REMARKS

Reconsideration and allowance of the present application based on the following remarks are respectfully requested.

FIG. 11

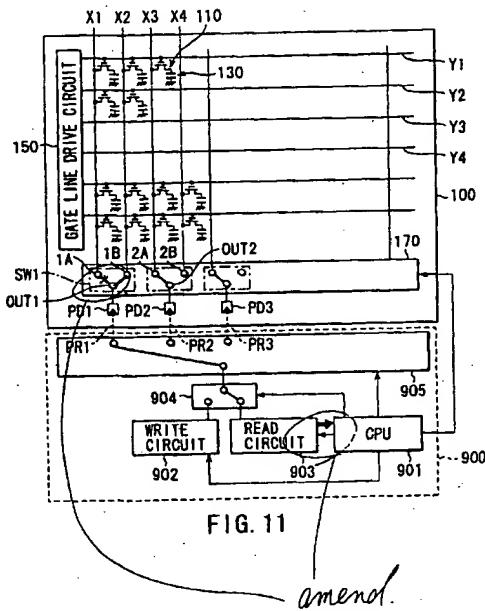
With regard to the drawings, the method of inspecting a short circuit between adjacent signal lines by the control of the CPU (901) is described in the specification, for example, from page 30, line 14 to page 34, line 25 and shown in FIGS. 10 and 11. In particular, as described on page 31, line 24 through page 32, line 10, and as shown in Figure 11, CPU 901 controls the read circuit 903 and reads output signals from the second signal line X2, and judges whether or not there is a short circuit between the first signal line X1 and the second signal line X2.

A corrected sheet of drawing with a substitue Figure 11 is provided with this Amendment. The corrected portions are shown in the following:
